**PCN# 20080122006
Datasheet Errata for TS3A44159 Device Types
Information Only**

PCN Number:	20080122006	PCN Date:	01/31/2008
Title:	Datasheet Errata for TS3A44159 Device Type		
Customer Contact:	Linda K Miles	Phone:	903-868-7638
Dept:	Standard Linear and Logic		
Proposed 1st Ship Date:	N/A	Estimated Sample Availability:	N/A
Change Type:			
<input type="checkbox"/>	Assembly Site	<input type="checkbox"/>	Assembly Process
<input type="checkbox"/>	Design	<input checked="" type="checkbox"/>	Electrical Specification
<input type="checkbox"/>	Test Site	<input type="checkbox"/>	Packing/Shipping/Labeling
<input type="checkbox"/>	Wafer Bump Site	<input type="checkbox"/>	Wafer Bump Material
<input type="checkbox"/>	Wafer Fab Site	<input type="checkbox"/>	Wafer Fab Materials
<input type="checkbox"/>		<input type="checkbox"/>	Assembly Materials
<input type="checkbox"/>		<input type="checkbox"/>	Mechanical Specification
<input type="checkbox"/>		<input type="checkbox"/>	Test Process
<input type="checkbox"/>		<input type="checkbox"/>	Wafer Bump Process

Page 1

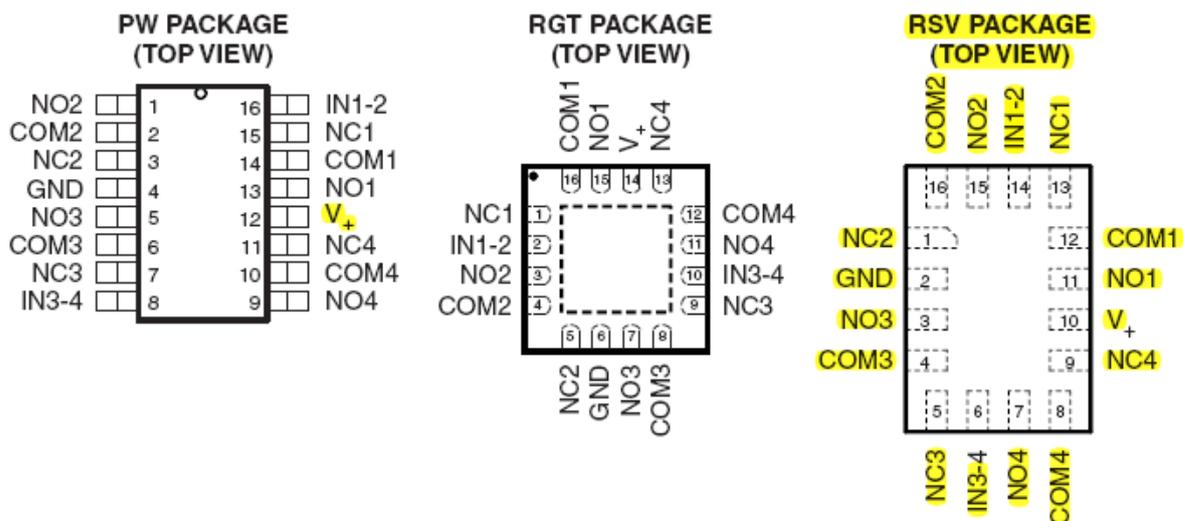
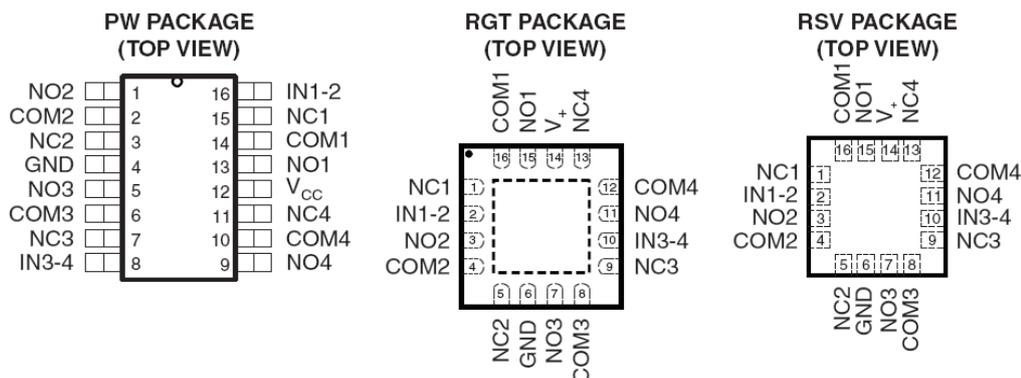
Texas Instruments is modifying the package drawings for the TS3A44159 to display the correct pin outs. We are also correcting the Leakage current limits and the Vin max in the tables shown below. The changes are shown highlighted in yellow.
